SUPPLEMENT TO BLOOMFIELD REFINERY DISCHARGE PLAN APPLICATION, SITE INVESTIGATION AND ABATEMENT PLAN CMS

**RE: Corrective Measures Study (Site Investigation and Abatement Plan)
Giant Refining Company, Bloomfield Refinery
EPA ID# NMD089416416
HWB-GRCB-01-001**

SUBJECT: REQUEST FOR SUPPLEMENTAL INFORMATION (RSI)
CORRECTIVE MEASURES STUDY (SITE INVESTIGATION AND
ABATEMENT PLAN)
GIANT REFINING COMPANY, BLOOMFIELD REFINERY
EPA ID# NMD089416416
HWB-GRCB-01-001

**RE: SITE INVESTIGATION REPORT AND ABATEMENT PLAN
GIANT BLOOMFIELD REFINERY (GW-001)**

Giant Groundwater Collection System Bloomfield, New Mexico AMEC Project No. 2-517-000001	 6019 Jefferson NE Albuquerque, New Mexico 87113	South Collection System - Side View Figure No. 2 Date Drawn: 8 July 2002 Drawn By: RJT Checked By: LW
---	---	--

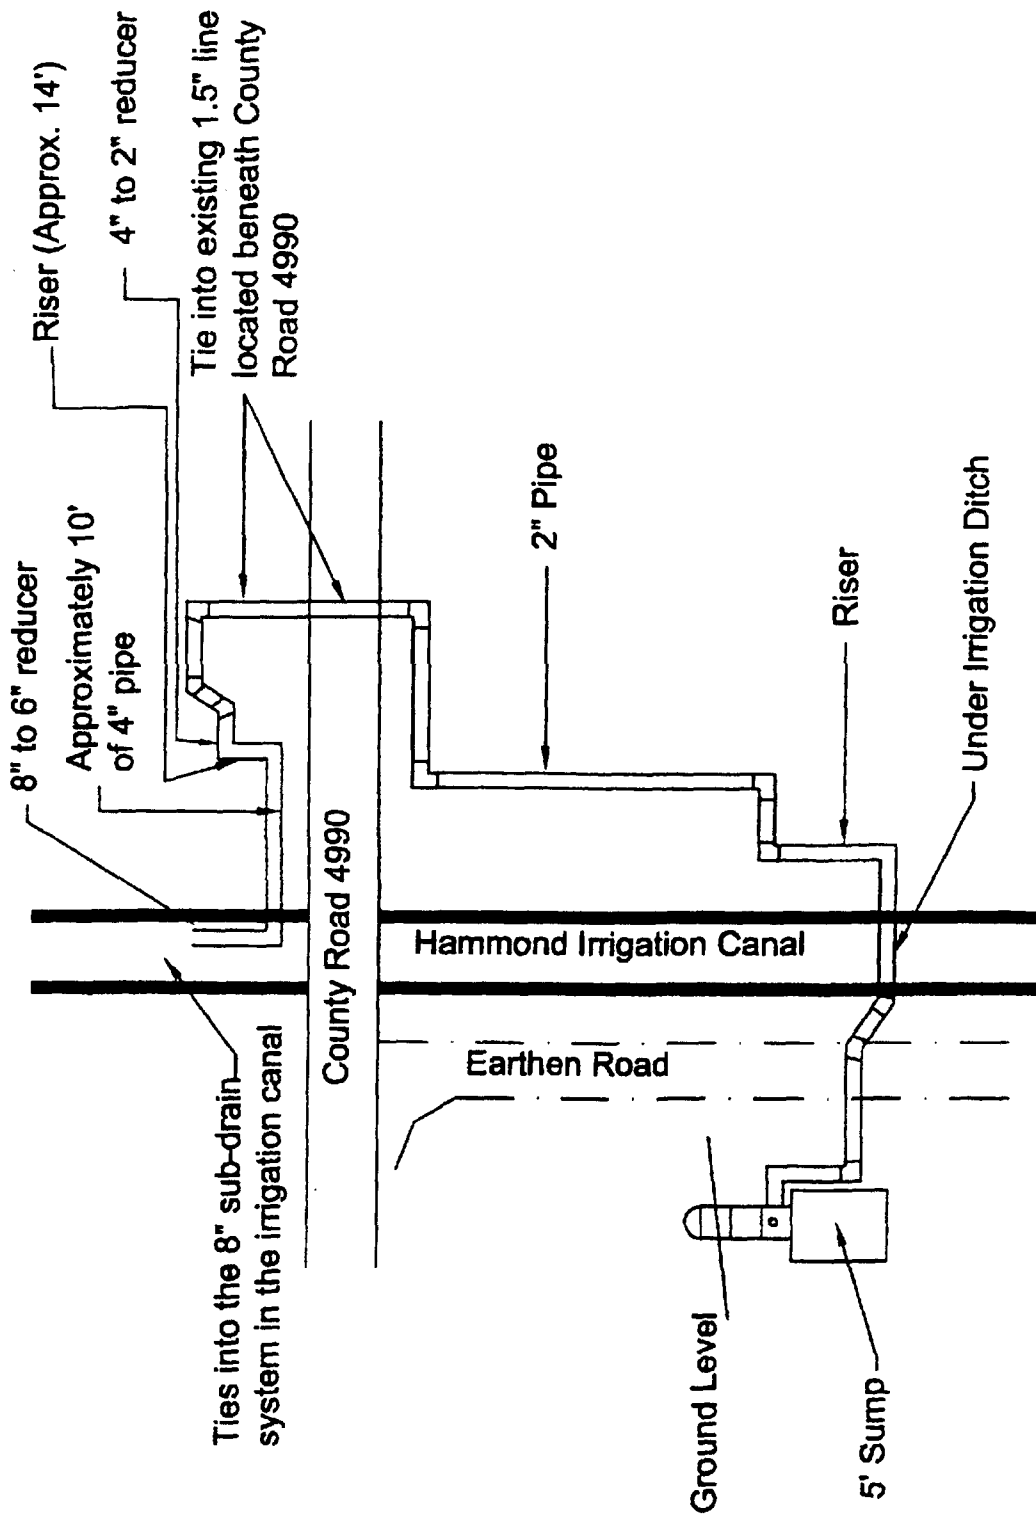
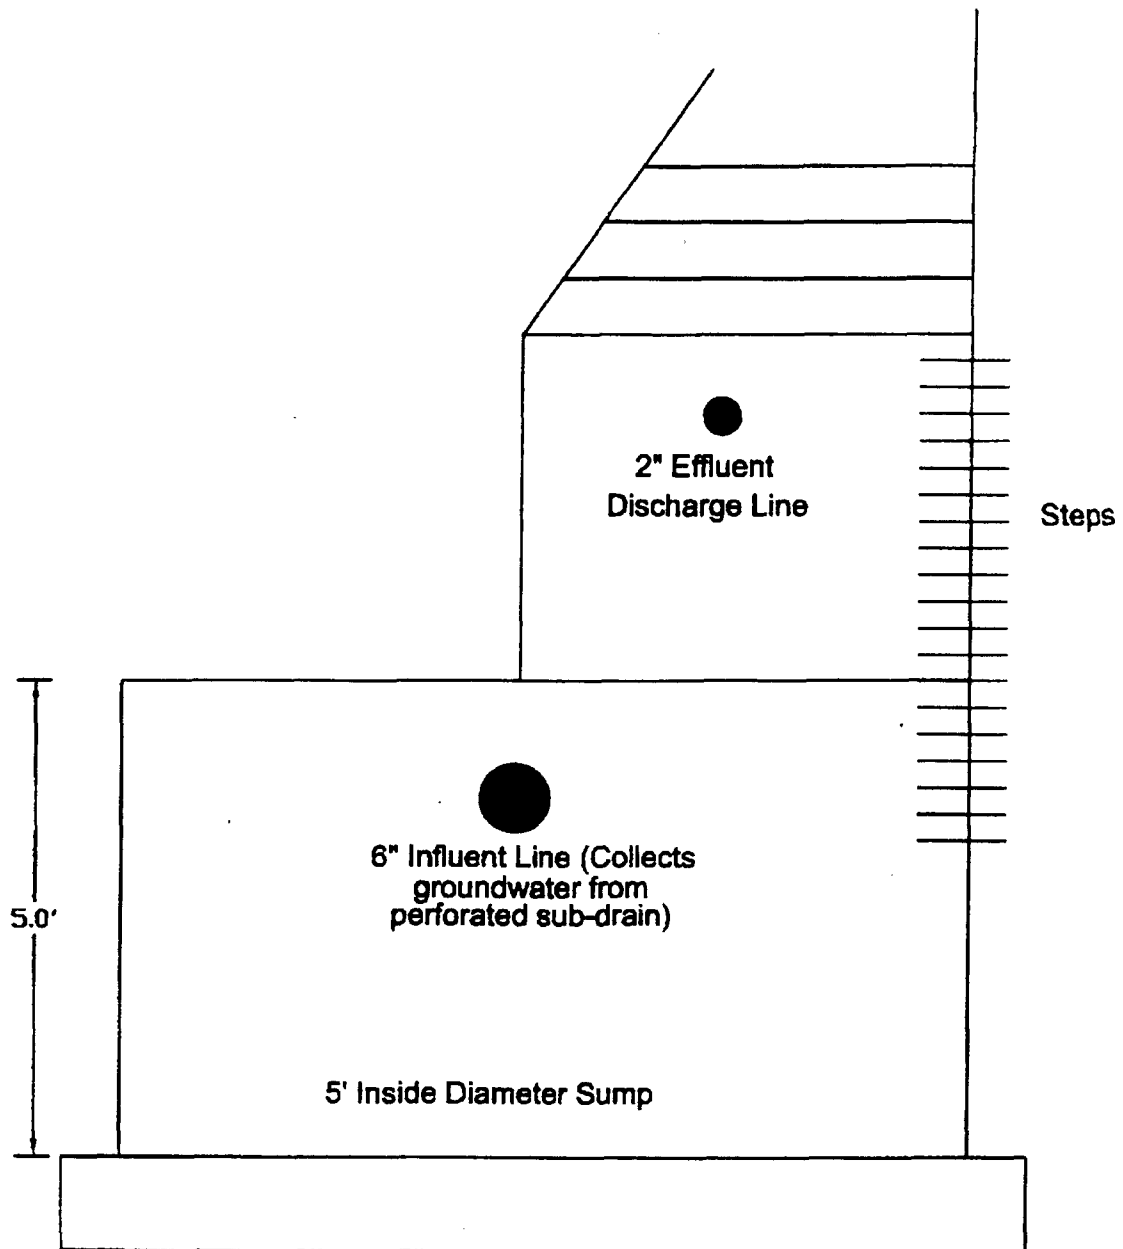
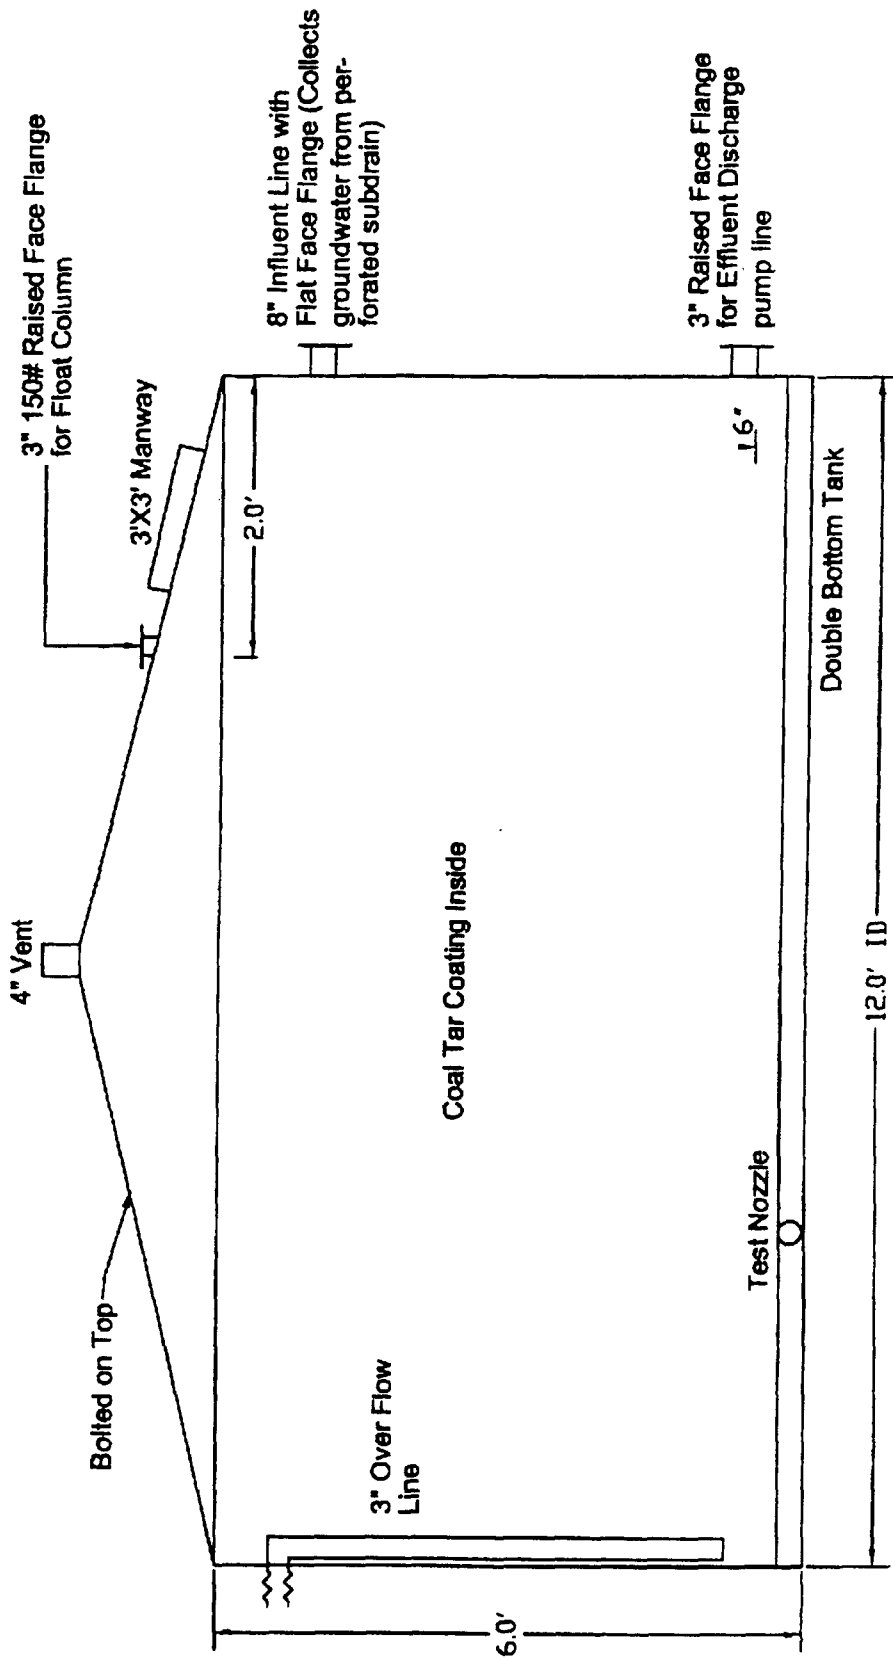
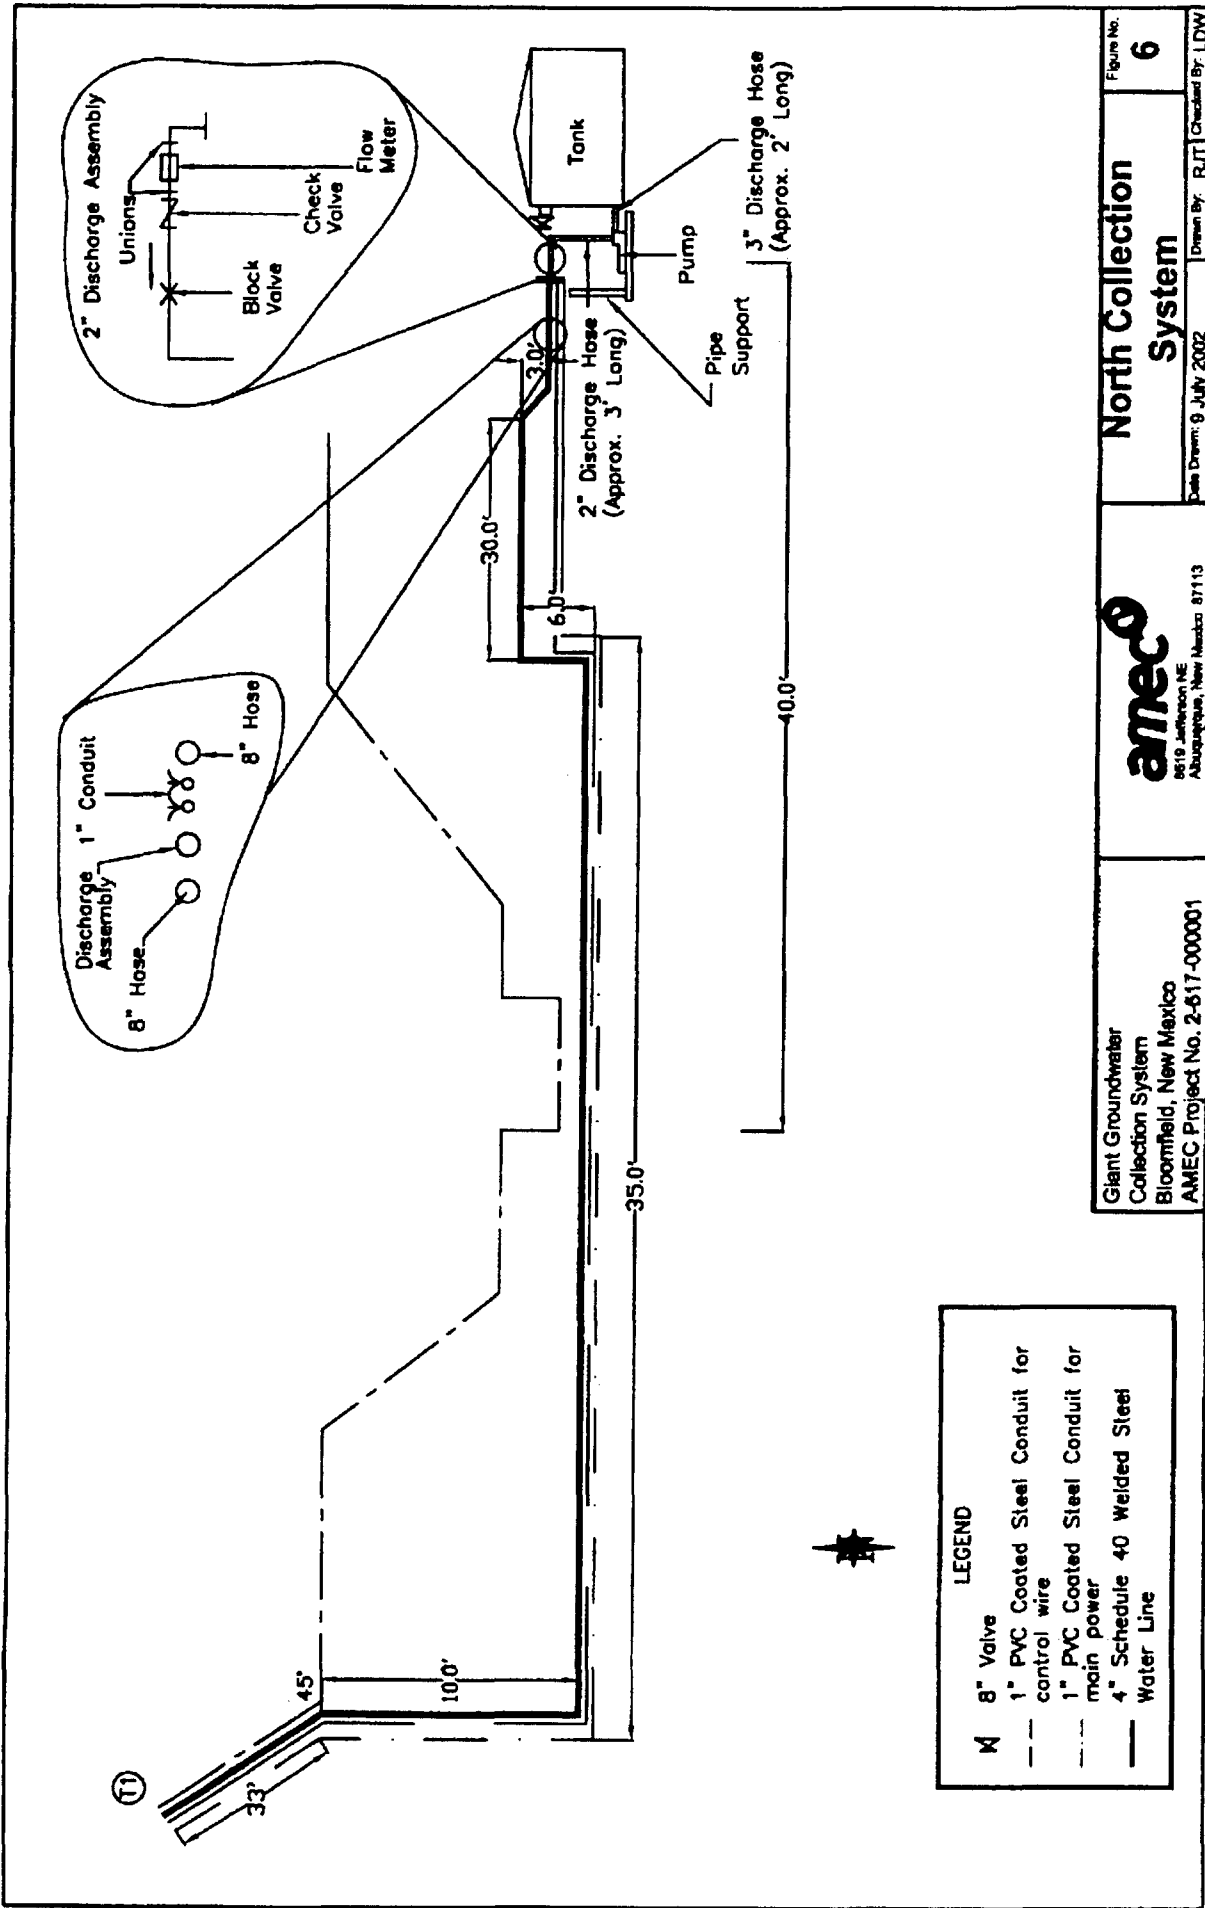
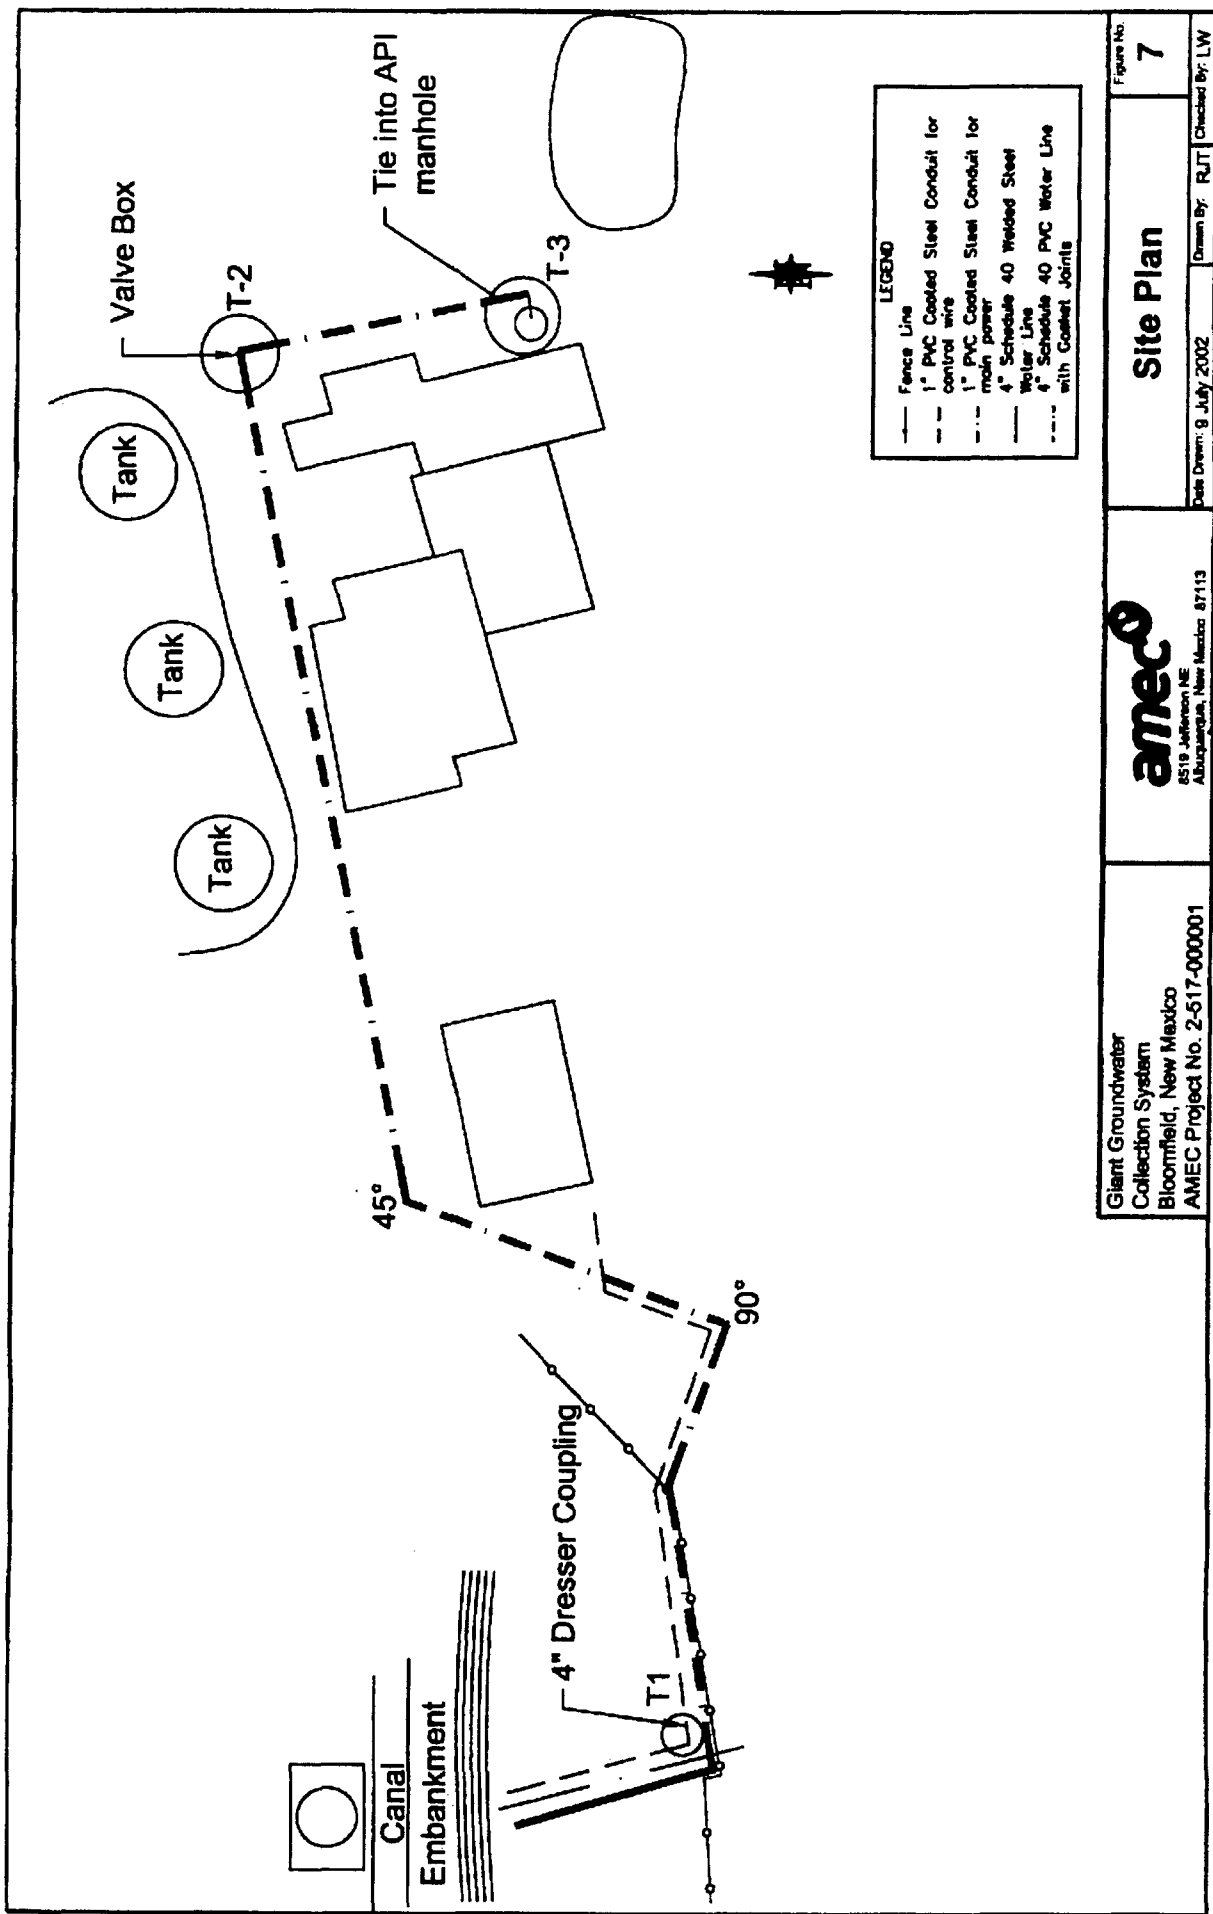
- An as-built (cross-section) drawing of the Hammond Ditch that shows the embankments, ditch, concrete lining, bedding, and French Drain. This drawing provided in both 8½" by 11" and 11" by 17" sizes.
- As-built drawings (9 pages - 8½" by 11" size) of the groundwater collection system from the Hammond Ditch French Drain to the API separator, and includes:
 - gravity-flow piping from the French Drain into Recovery Tank 37
 - details of Recovery Tank 37
 - all piping and instruments for the system
 - site plan showing the layout of the system
 - an 8½" by 11" copy of a photograph of Recovery Tank 37

This attachment also includes a series of 9 as-built drawings (Figures 1 – 9) of the groundwater collection system from the Hammond Ditch French Drain to the API Separator. The series of drawings include the north and south collection systems; the gravity flow piping from the French Drain into Recovery Tank 37; the piping and instruments for the system; details of Recovery Tank 37; and a site plan showing the layout of the system. A copy of a photograph of Recovery Tank 37 is inserted at the end of this section.

Recovery Tank 37

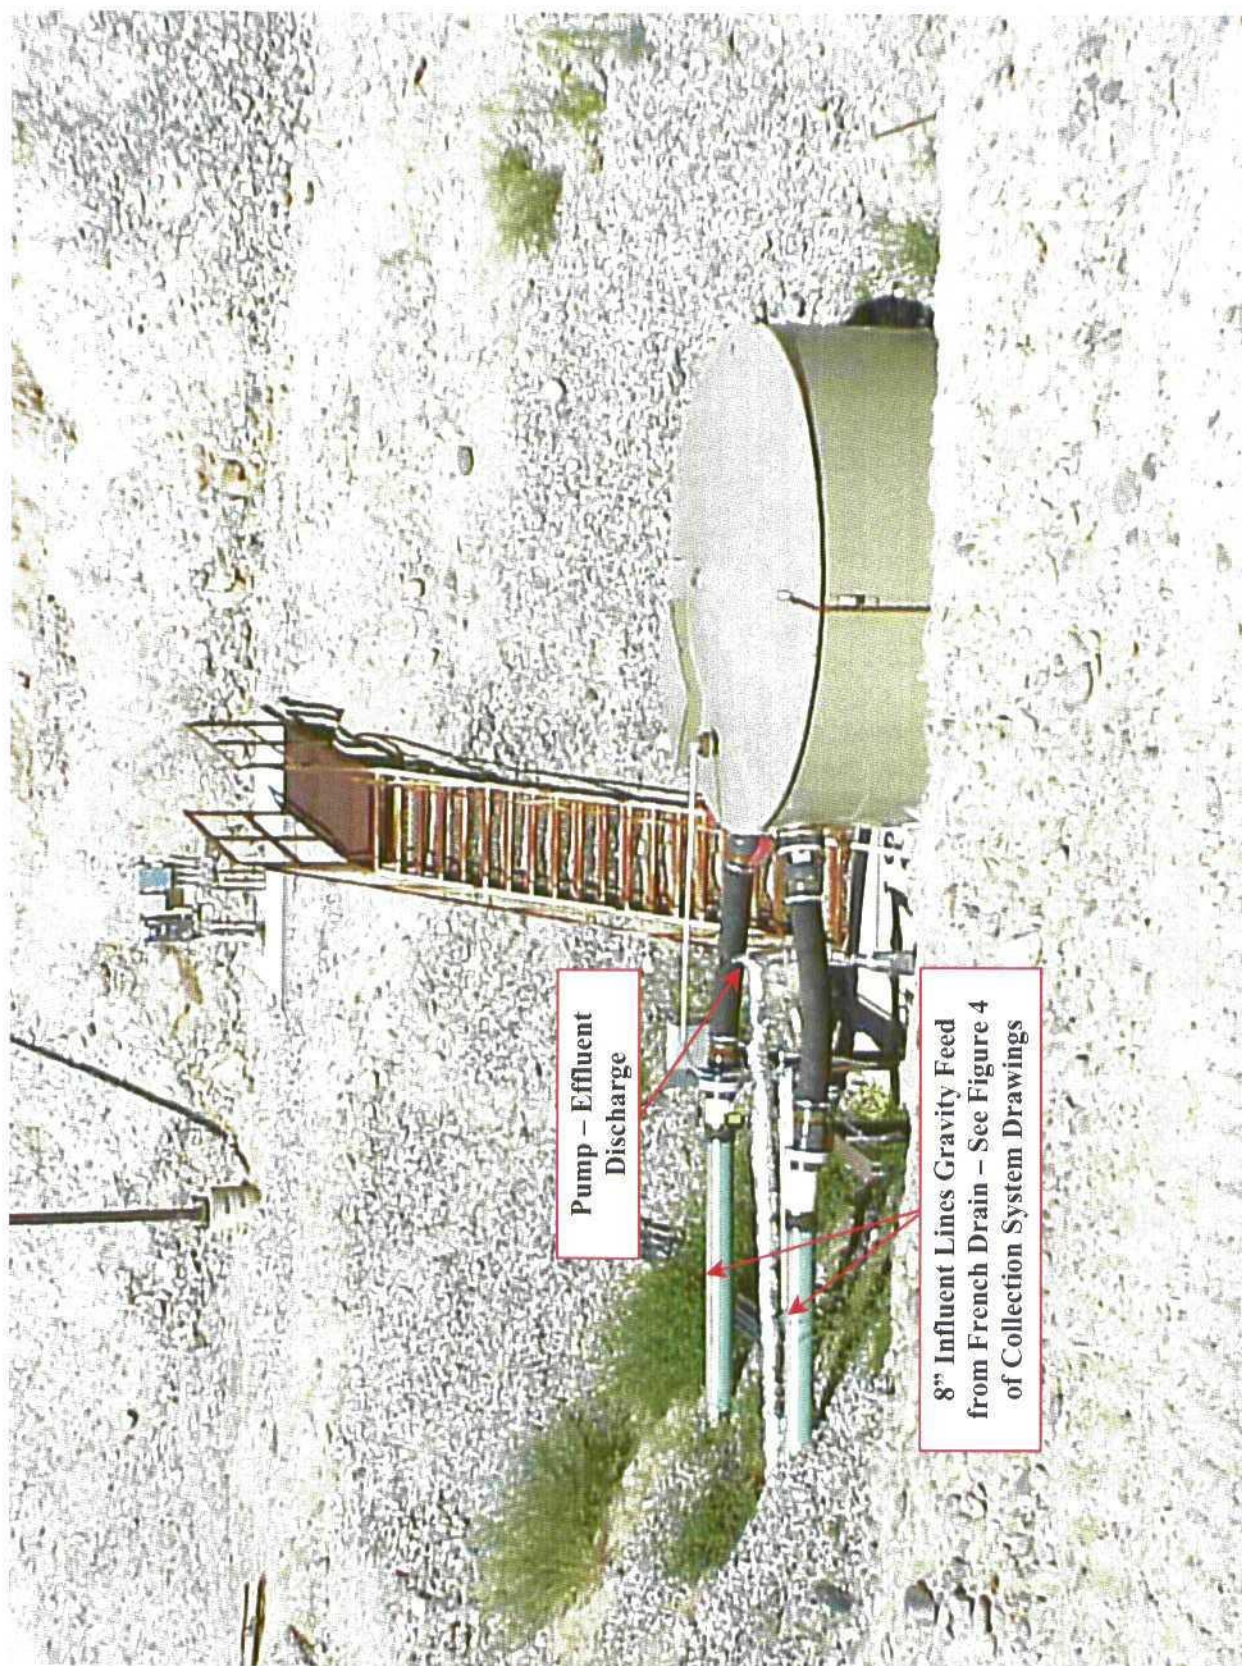
Attachment 4 includes a table of the flow rates from the flow meter shown in Figure 6 of the Hammond Ditch French Drain groundwater collection system (Attachment 2). The monitored flow rates from the meter on Tank 37 and a graph of the information are included.
